# STARBUCK ENGINEERING CHANGE NOTICE

1. ECN 169879

13b. Justification Details  
 To update the Groundwater Monitoring Plan to document monitoring well placement for the 1993 drilling program. Locations are based on the Part 8 Dangerous Waste Permit (DOE/RL-88-27, Rev. 2), and discussions with Washington State Department of Ecology.

Figure 3.1. Map Showing the Locations of Existing and Planned Monitoring Wells at the Grout Treatment Facility.-

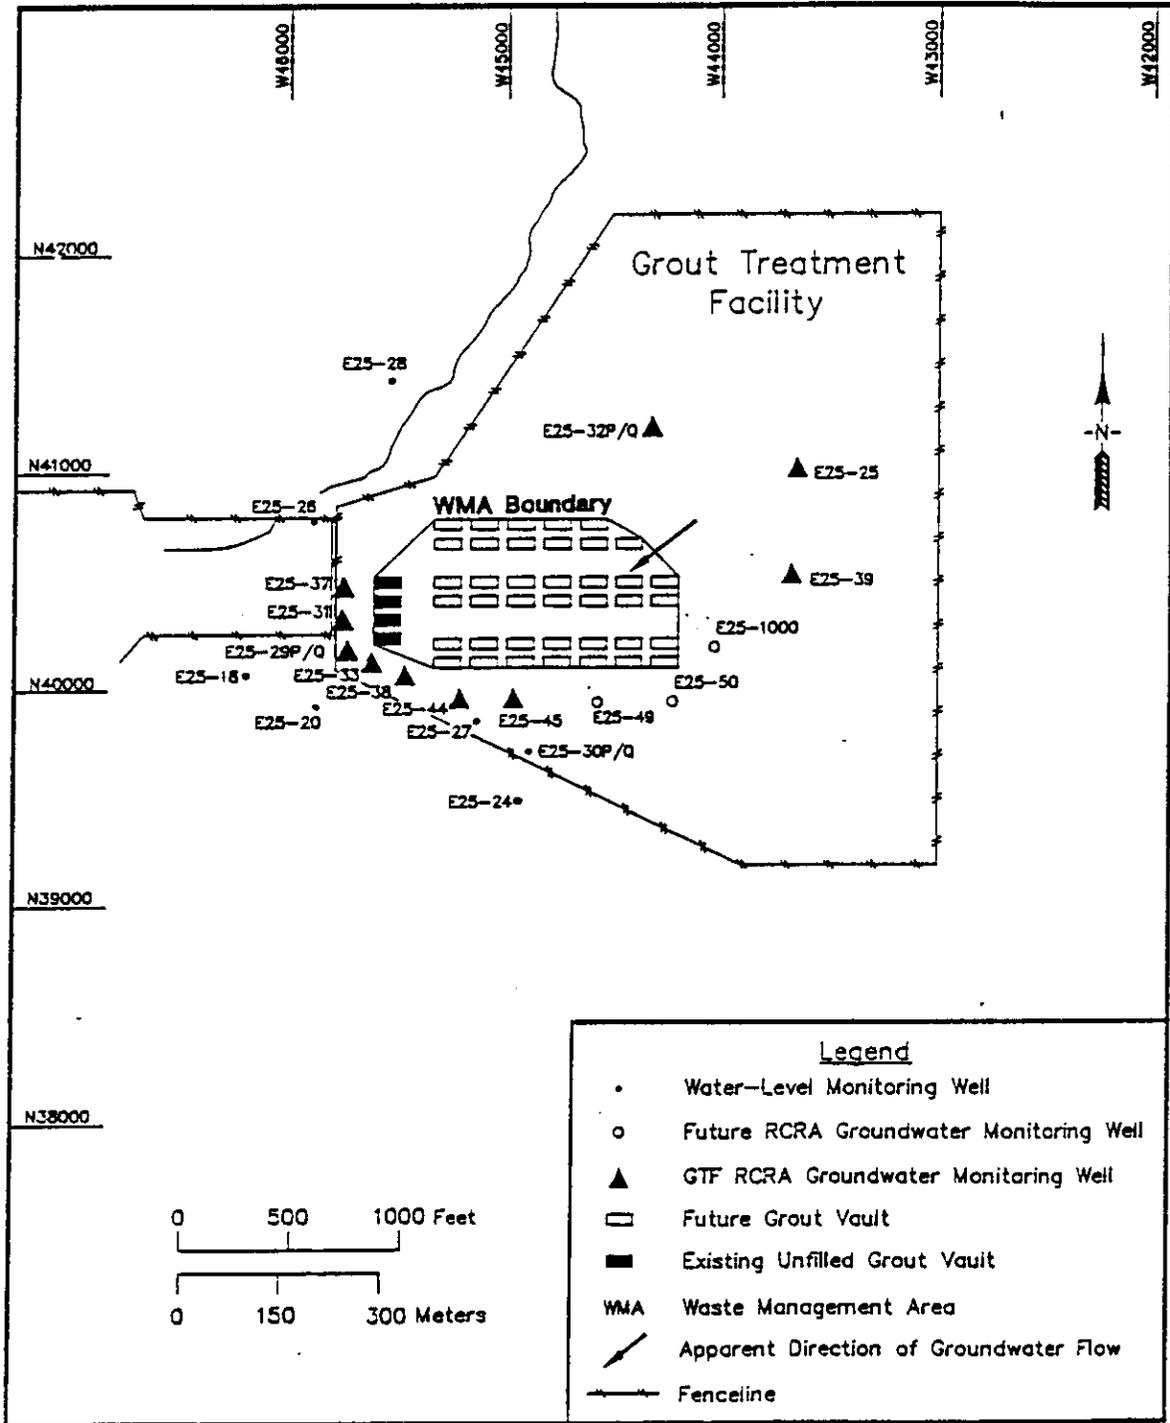
1. The paragraph added to page 55, in the section entitled, Installation of New Characterization/Monitoring Wells, should be revised and expanded to:  
 Five downgradient wells are proposed for construction along the GTF point of compliance: two wells in 1992 and three in 1993. The 1992 wells will be spaced 250 ft apart and the 1993 wells 350 ft apart. The wells will continue along the line of compliance that extends southeast and then east of well 299-E25-38, with the exception of well 299-E25-1000 (Figure 3.1).

3. Another revision of Figure 3.1 (attached), page 50, should replace the one in the groundwater monitoring plan.
